**VERIFICATION SURVEY
OF THE
BAKER AND WILLIAMS WAREHOUSES
BUILDING 521-527
NEW YORK, NEW YORK**

The report titled, Verification Survey of the Baker and Williams Warehouses Building 521-527 New York, New York, has been reviewed. The enclosed comments are enclosed for your use in preparing the final report.

**Comments on the Draft Report - Verification Survey of
the Baker and Williams Warehouses, Building 521-527,
New York, New York**

FIGURE 2: Floor Plan of Building 521-527 Ground Level

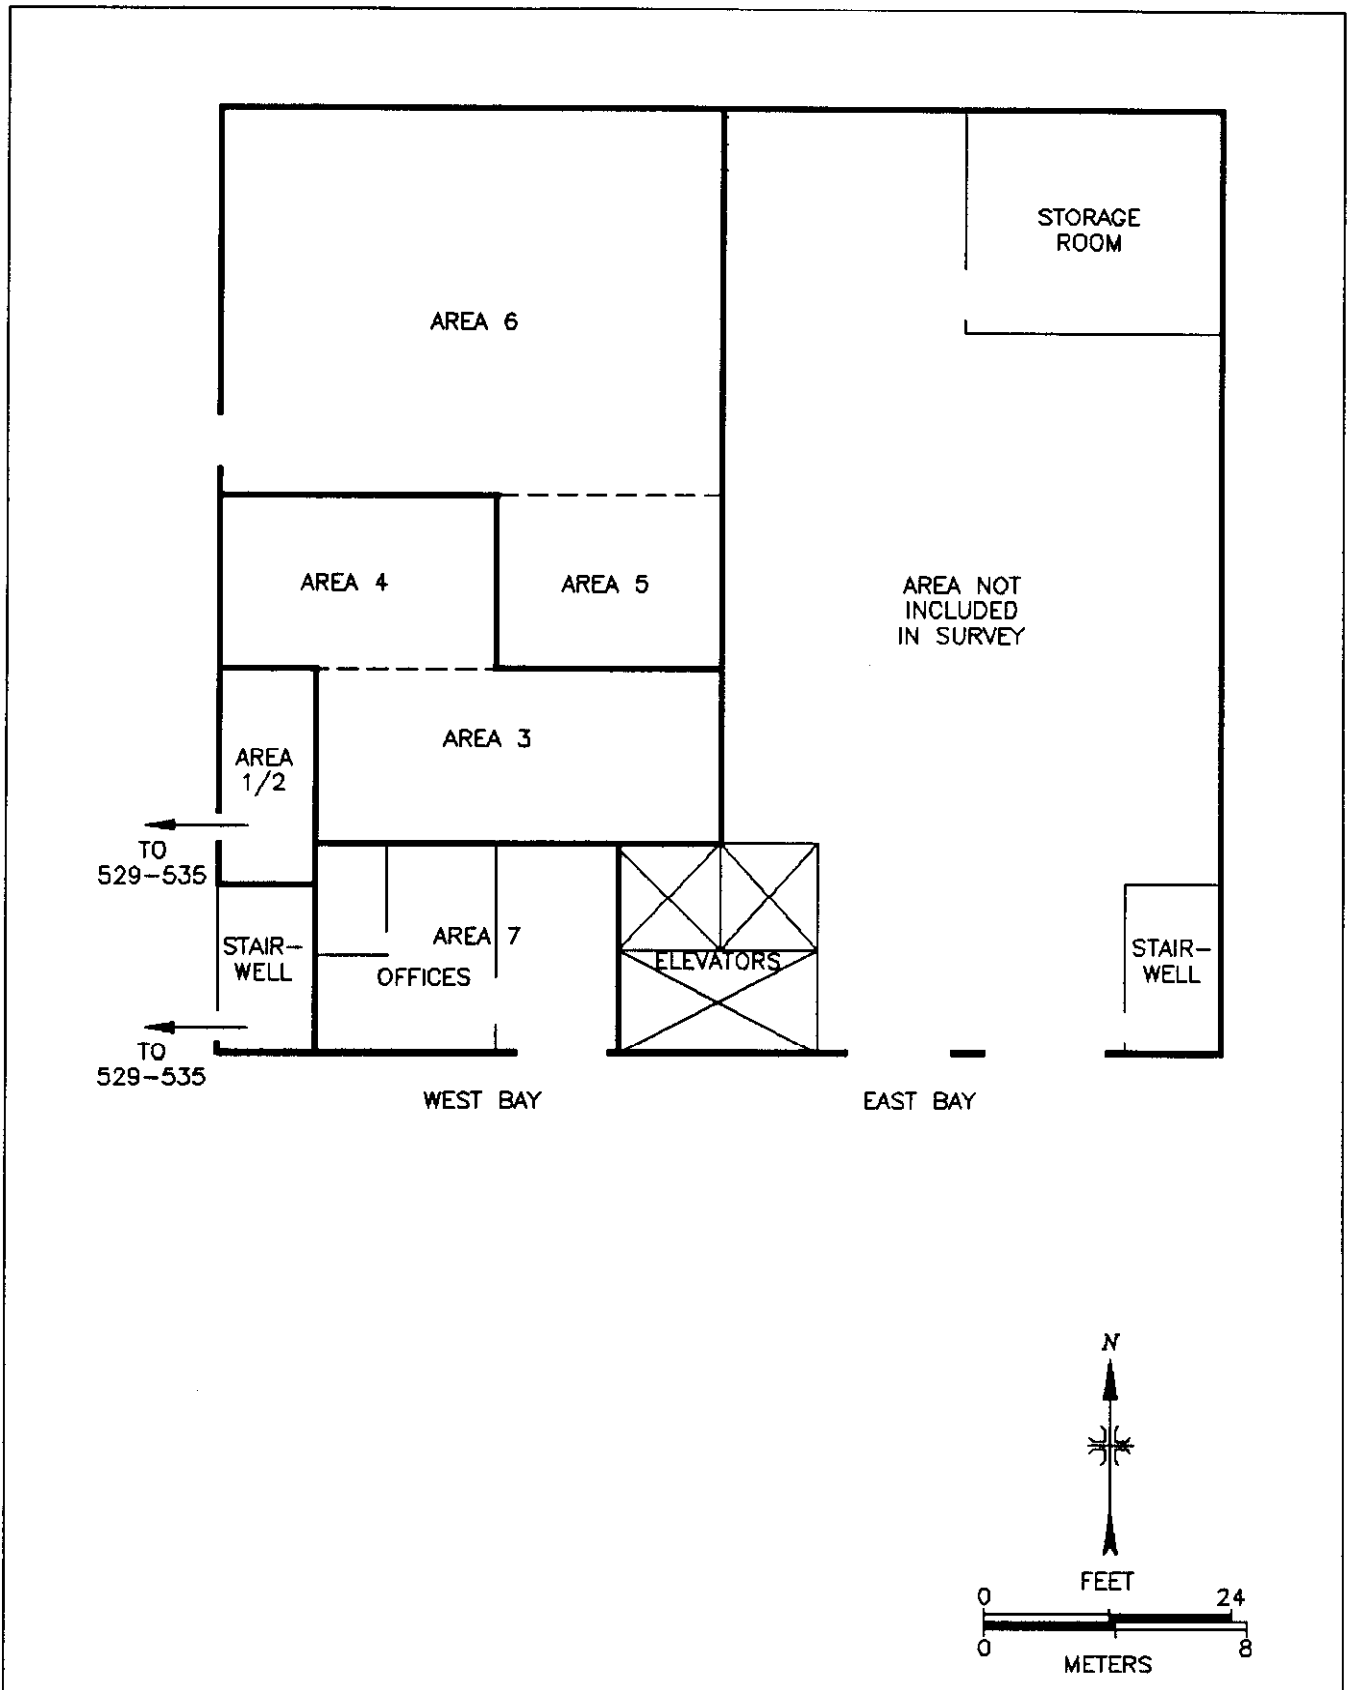
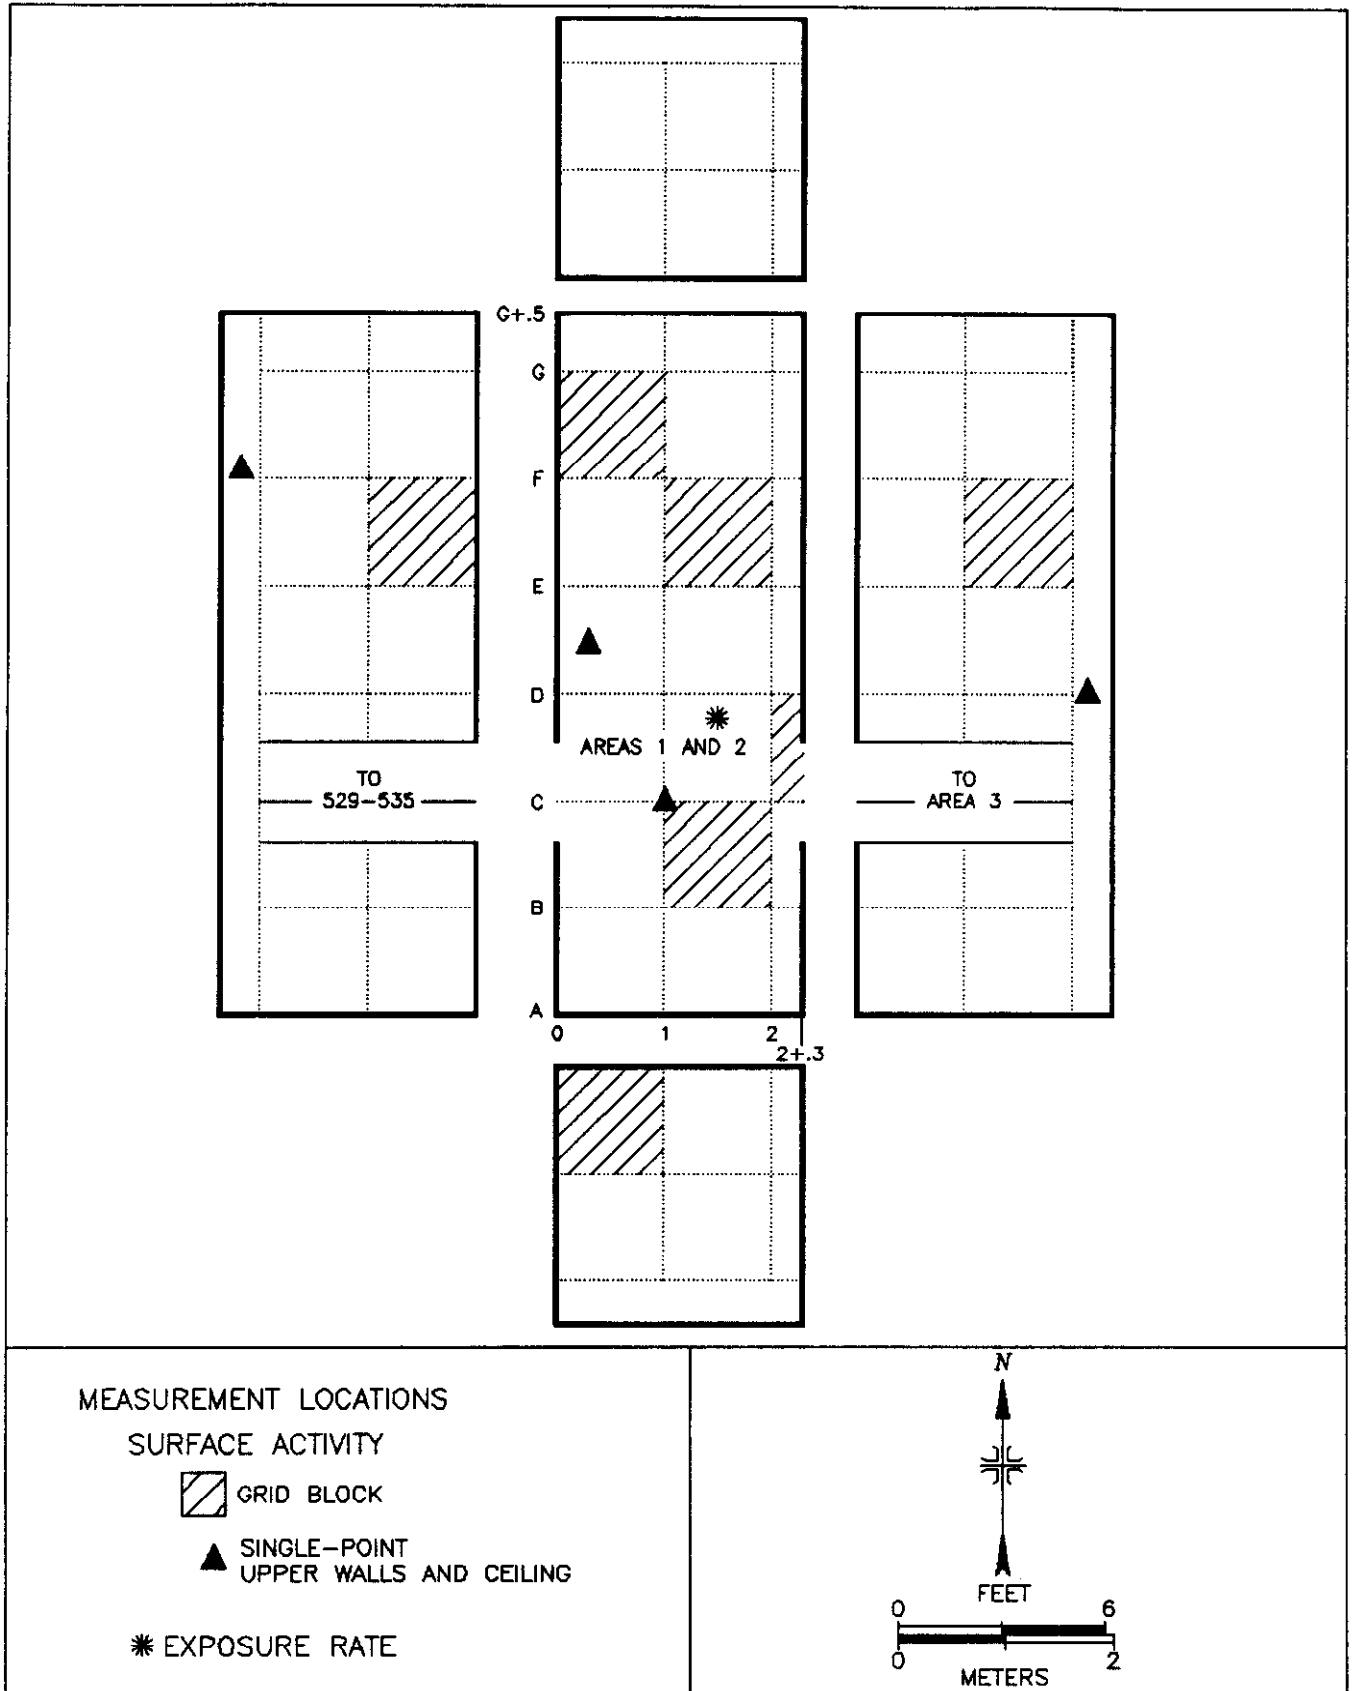
Page 12, Figure 2 and page 14, Figure 4 - The difference in the figures, both of the ground level, should be addressed in the text.
